Docket Number:	23-AFC-02
Project Title:	Elmore North Geothermal Project (ENGP)
TN #:	253081
Document Title:	Elmore North Geothermal Project Data Request Response Set 1 (Revised Responses to Data Requests 3, 4, 7, 10 to 13, and 69 to 73)
Description:	N/A
Filer:	Lindsey Xayachack
Organization:	Jacobs
Submitter Role:	Applicant Consultant
Submission Date:	11/13/2023 3:36:19 PM
Docketed Date:	11/13/2023

Data Response Set 1 (Revised Responses to Data Requests 3, 4, 7, 10 to 13, and 69 to 73)

Elmore North Geothermal Project
(23-AFC-02)

November 10, 2023

Figure 5.9-2
Operations Cancer Risk Isopleths
Elmore North Geothermal Project
 Imperial County, California

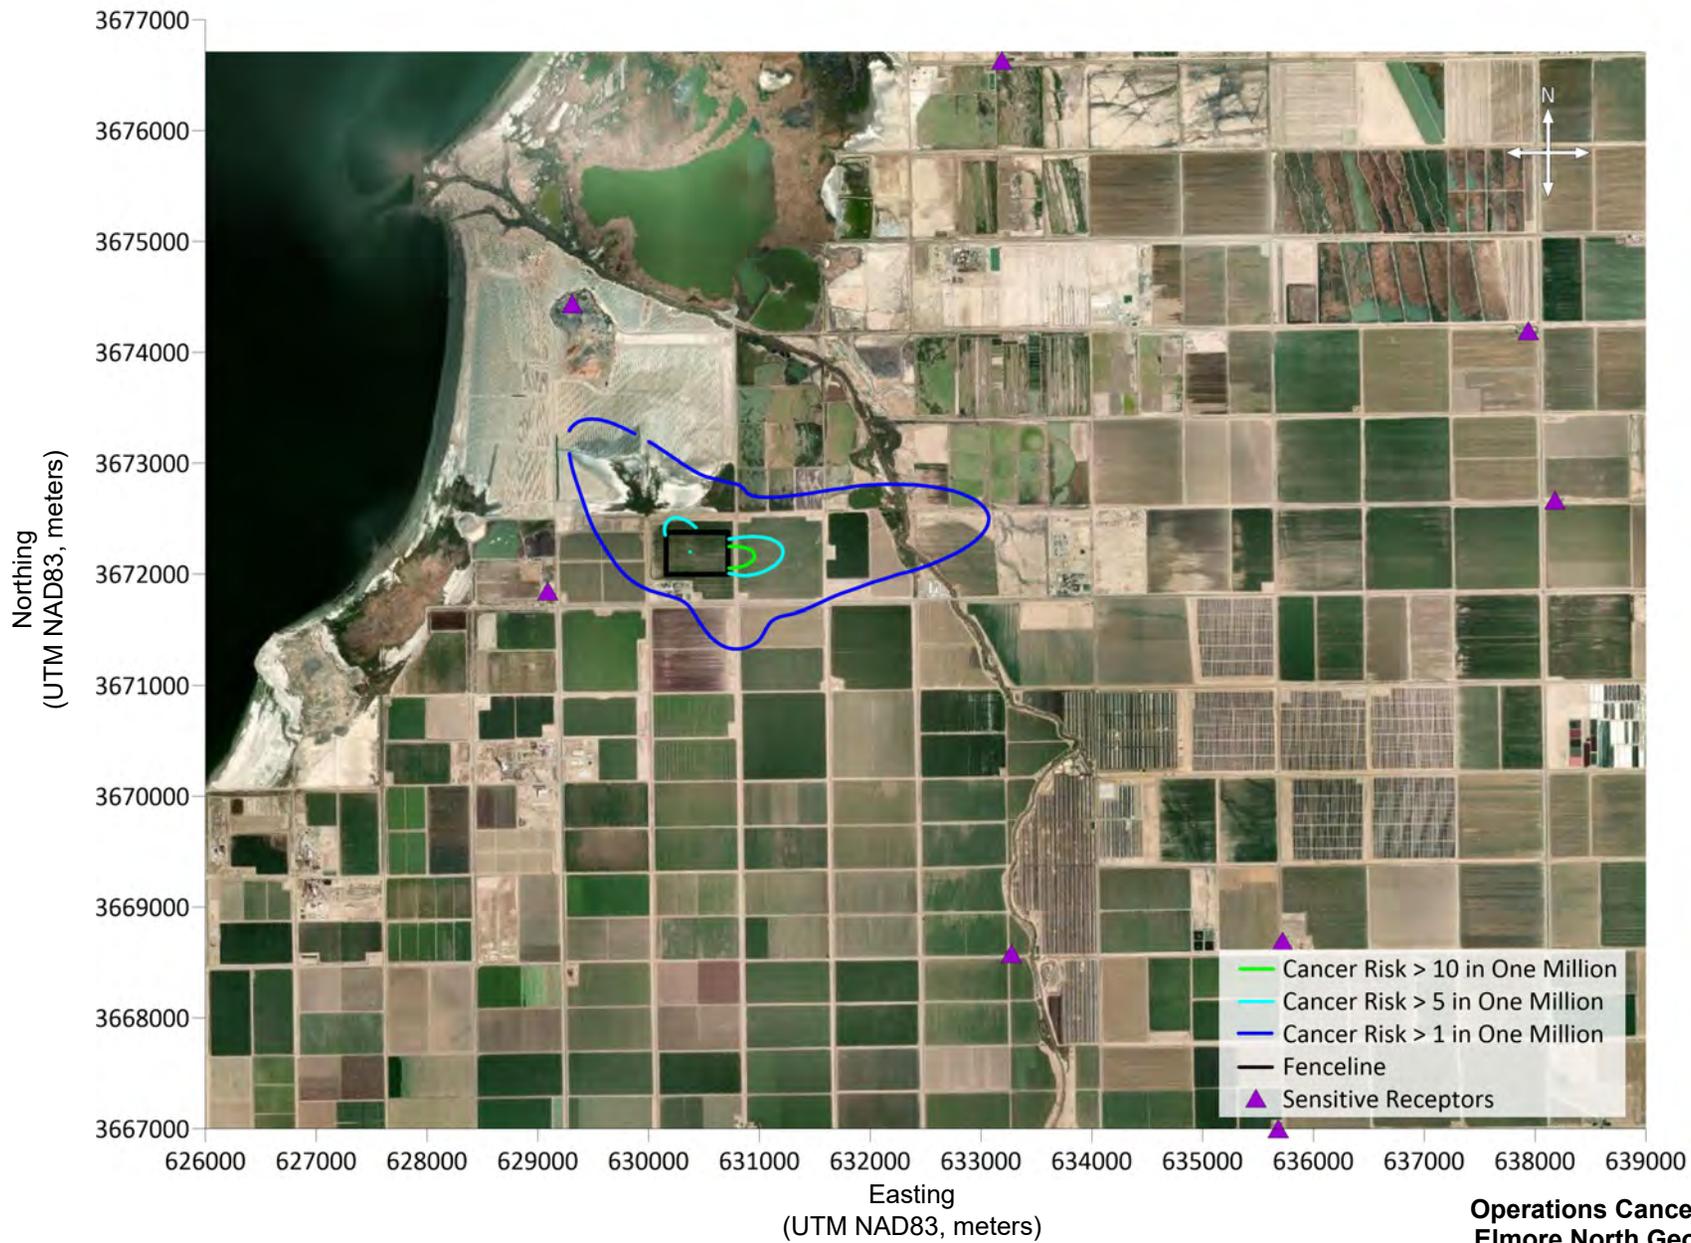
71. For residential exposures, please provide a map containing health risk isopleths, including an isopleth showing the risk value of 10 in a million.

Response: A map containing cancer risk isopleths reflective of the revised operational HRA modeling, including isopleths showing the risk values of 1, 5, and 10 in a million, is included as new Figure 5.9-2 of revised Section 5.9 from the AFC, which is included with this DRR as Attachment DRR 7-2. Additionally, Appendix 5.9A has been revised to incorporate refinements to the ENGP design. A spreadsheet version of revised Appendix 5.9A is included with this DRR as Attachment DRR 71-1.

Figure 5.9-4
Construction Cancer Risk Isopleths
Elmore North Geothermal Project
 Imperial County, California

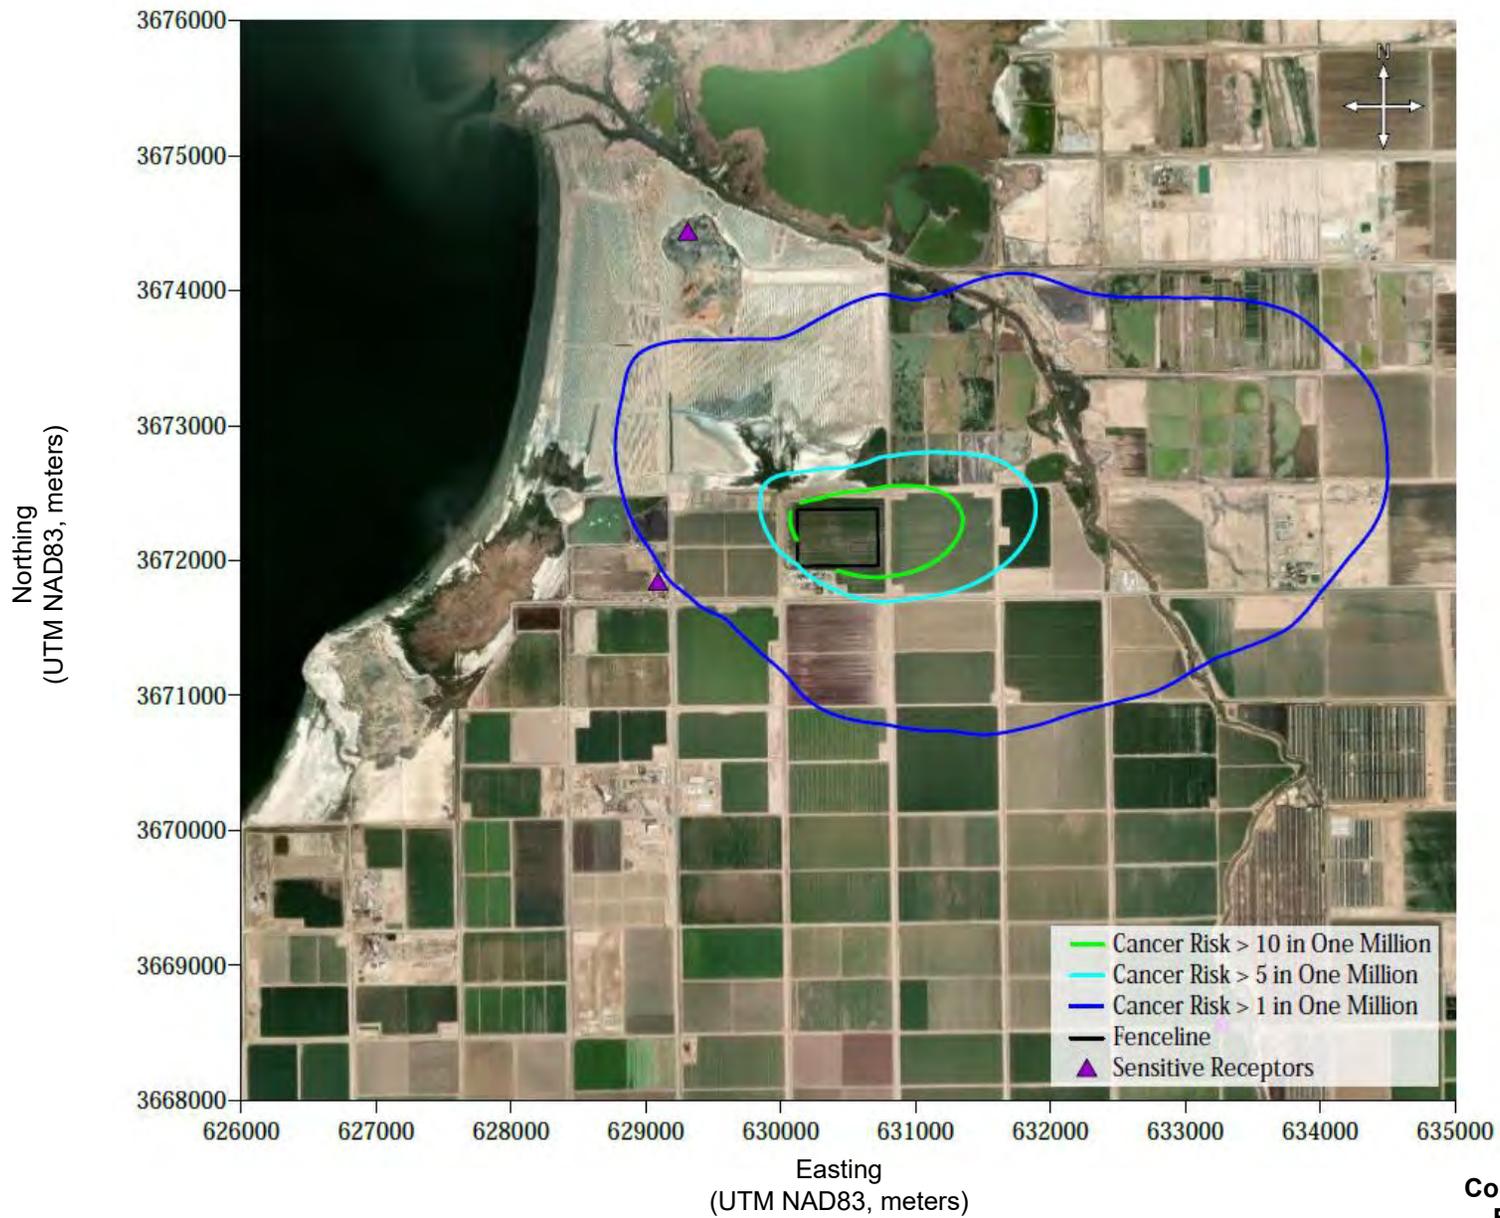
70. *For residential exposures, please provide a map containing health risk isopleths, including an isopleth showing the risk value of 10 in a million.*

Response: A map containing cancer risk isopleths reflective of the revised construction HRA modeling, including isopleths showing the risk values of 1, 5, and 10 in a million, is included as new Figure 5.9-4 of revised Section 5.9 from the AFC, which is included with this DRR as Attachment DRR 7-2.
